Addendum #1

Project: UO Lawrence Hall Re-Roof
Date: 05/15/2012
To: Bidding Contractors
From: Rowell Brokaw Architects

LAWRENCE HALL RE-ROOF
SK 051512-2
ADDENDUM #1
RBA 05/15/2012

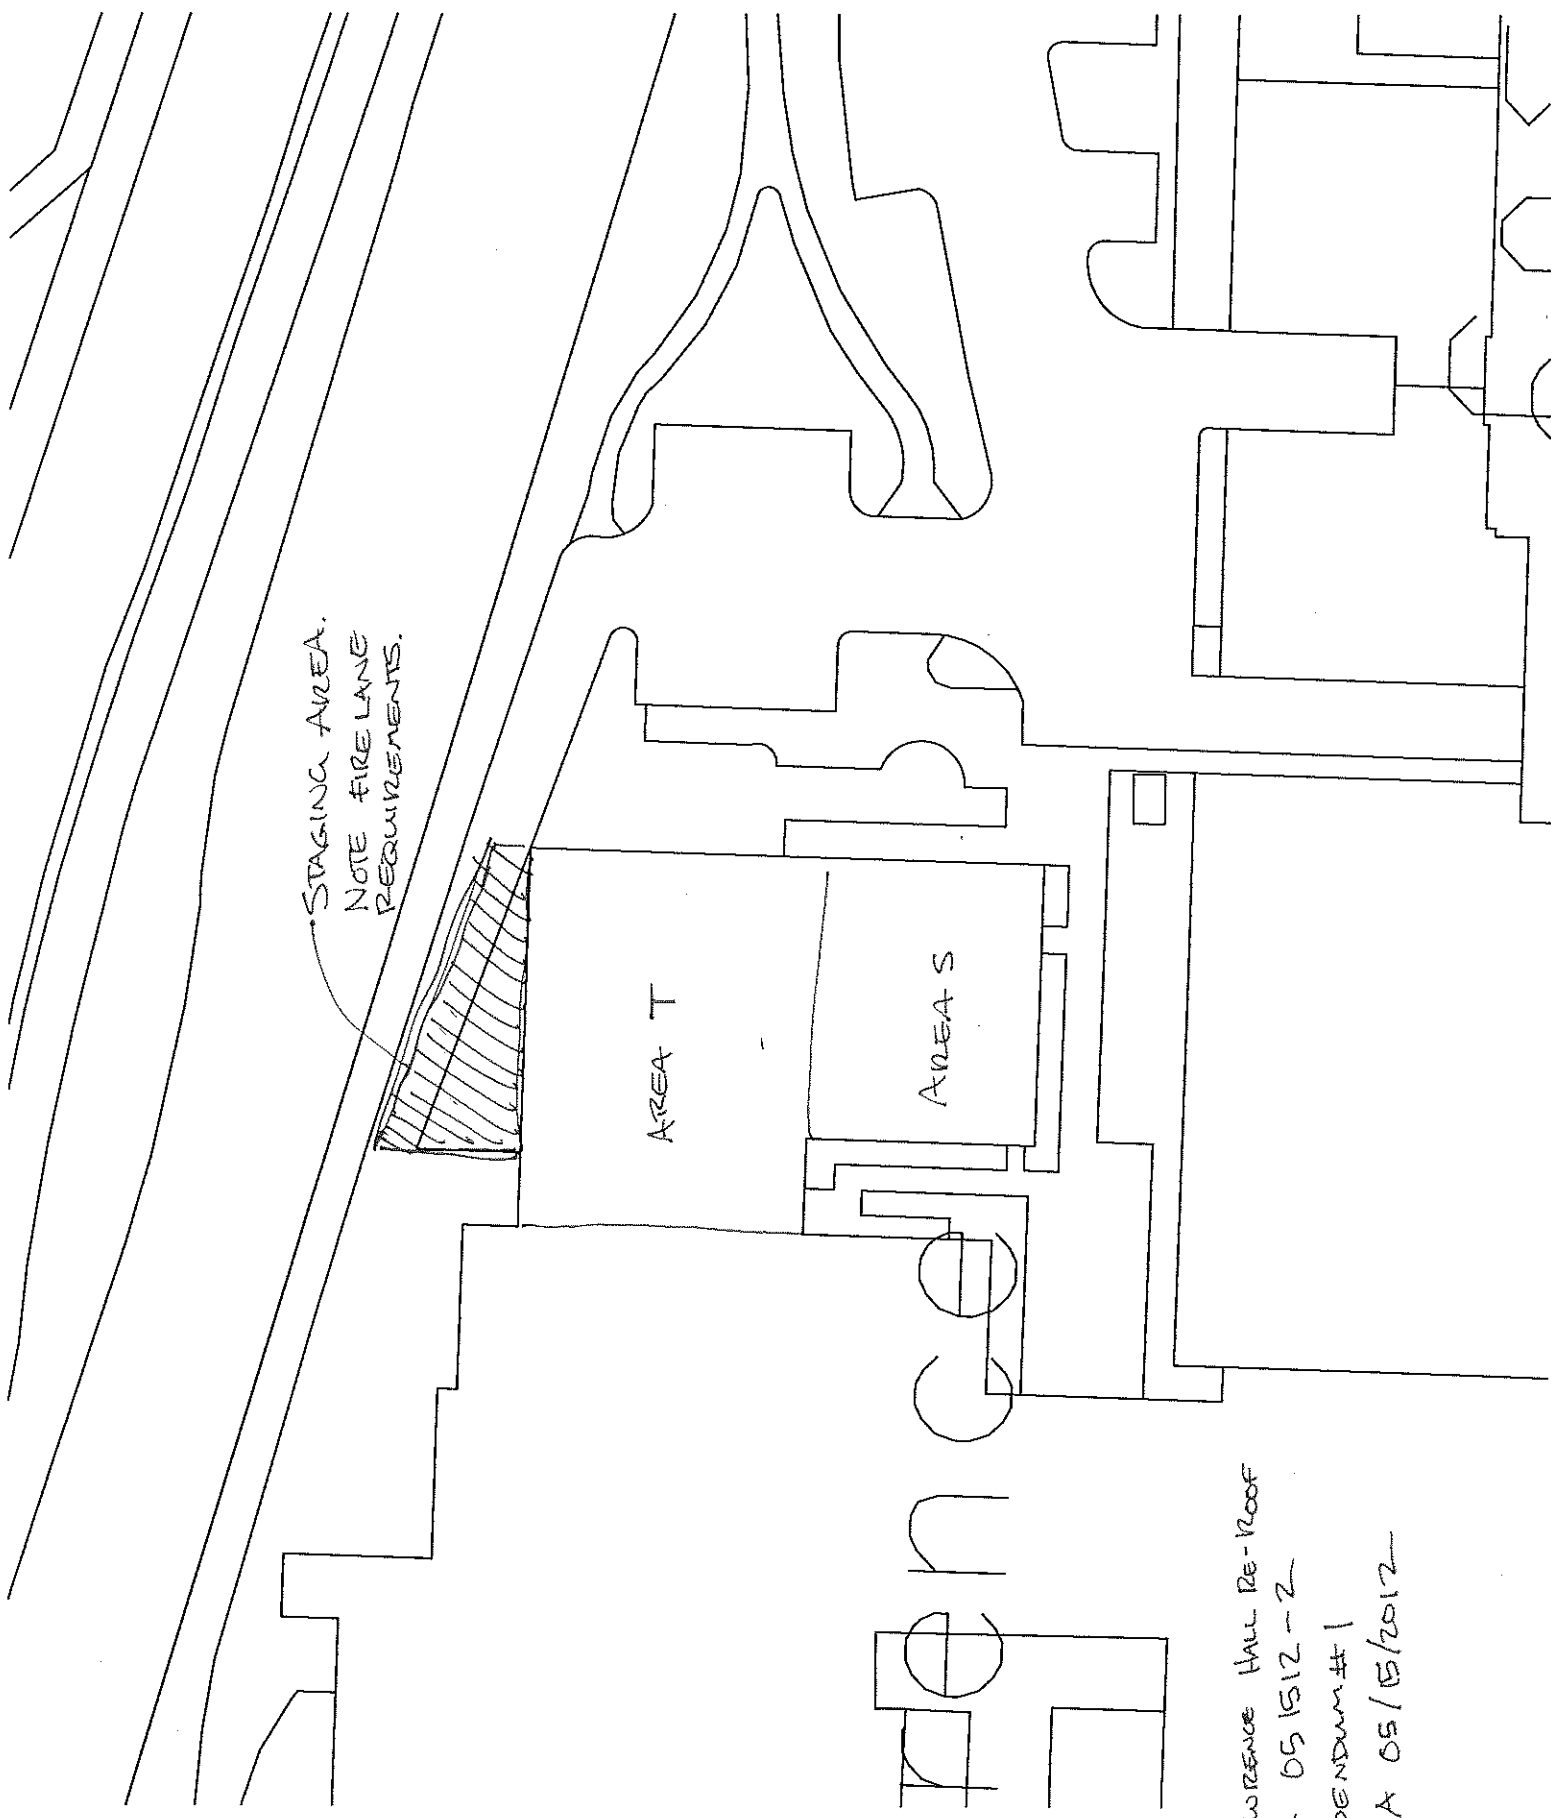
- A. Sketch SK 051512-2, showing approved staging area attached.
- B. Pre Bid Sign In sheet attached.
- C. There will be no bid bond requirement for this project.

SCUPPER DETAIL

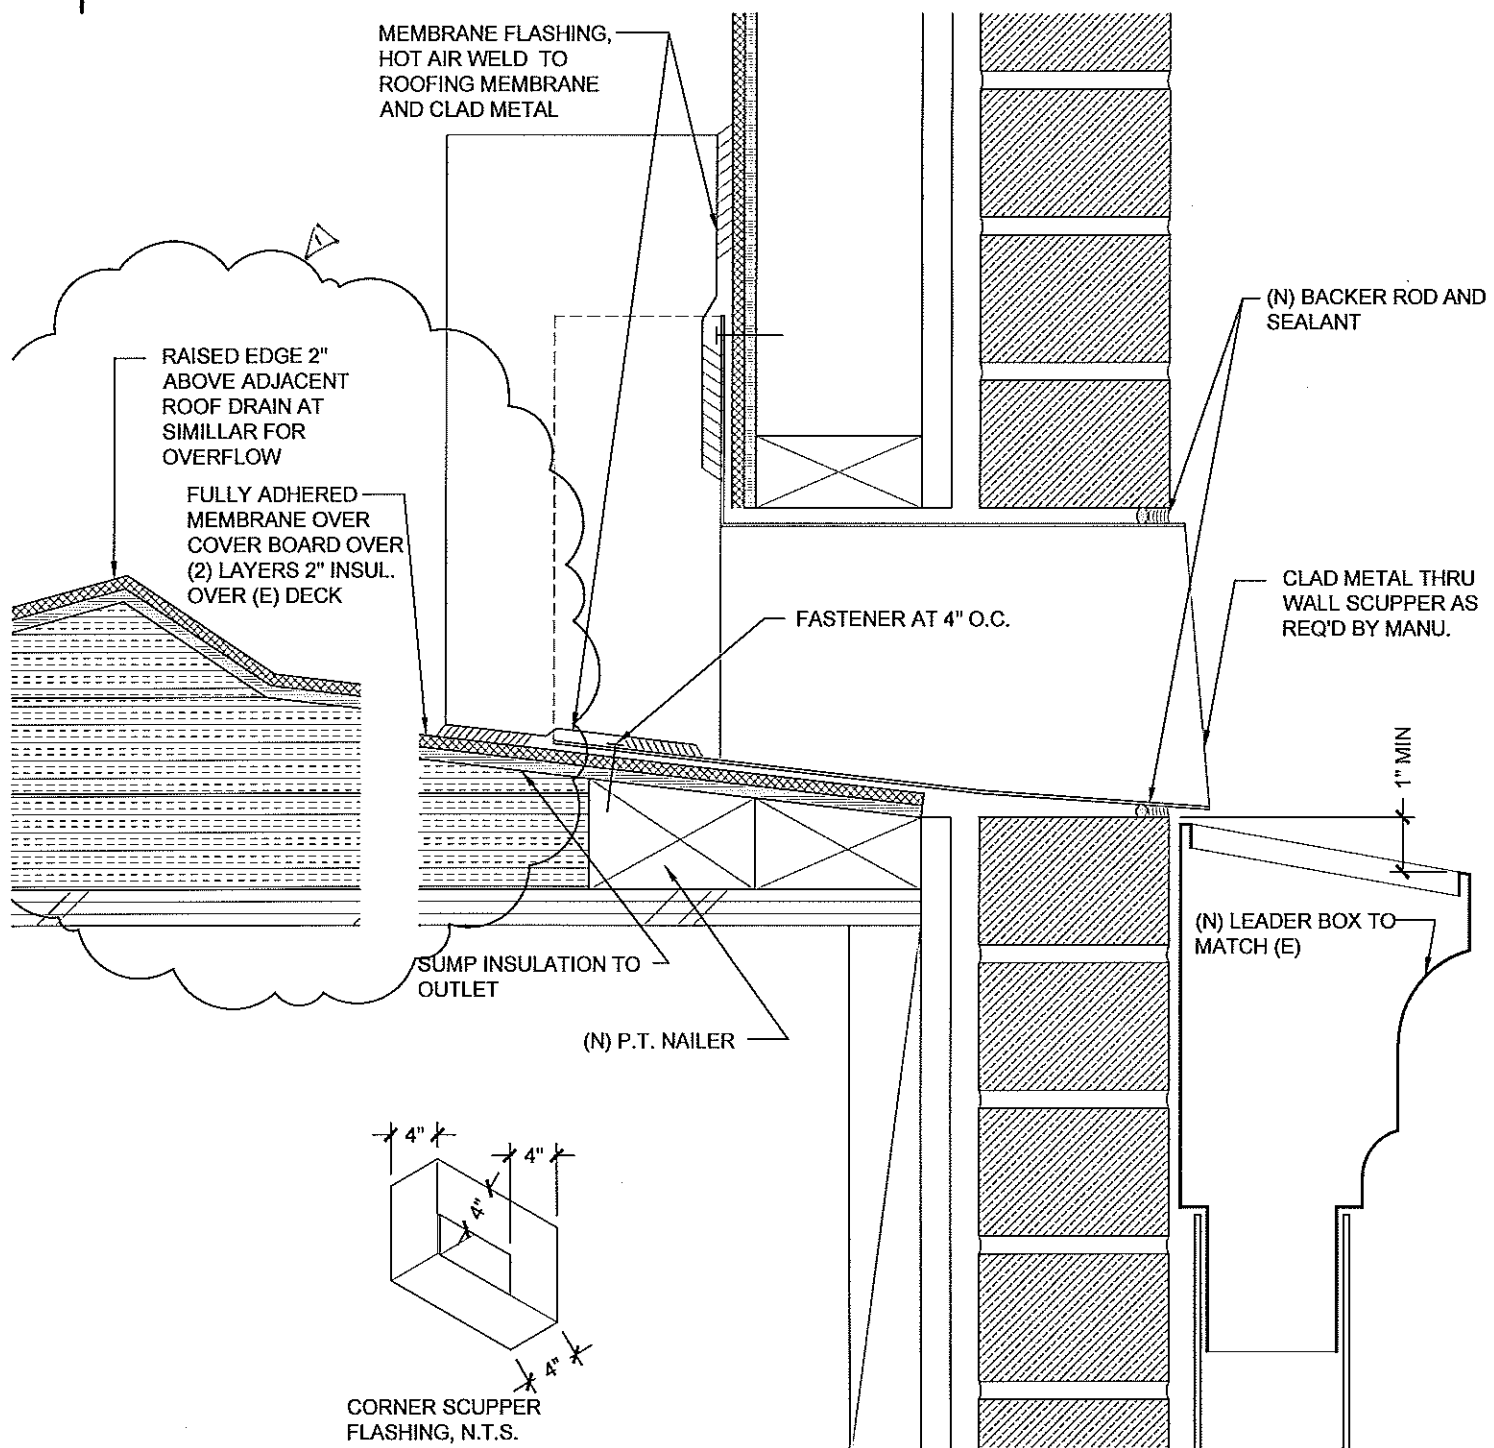
- A. Plan A2:
 - 1. Revise all detail tags at upper roof (Area T) to be detail tag 1/11.
 - 2. Place Detail tag "1/7 Sim." At overflow adjacent to roof drain on lower roof (Area S)
- B. Detail A5: Revise top most note to read: "TRIM (E) METAL WALL PANEL AS NECESSARY FOR ROOFING INSTALLATION. HEM NOT REQUIRED."
- C. revised detail A7 attached.
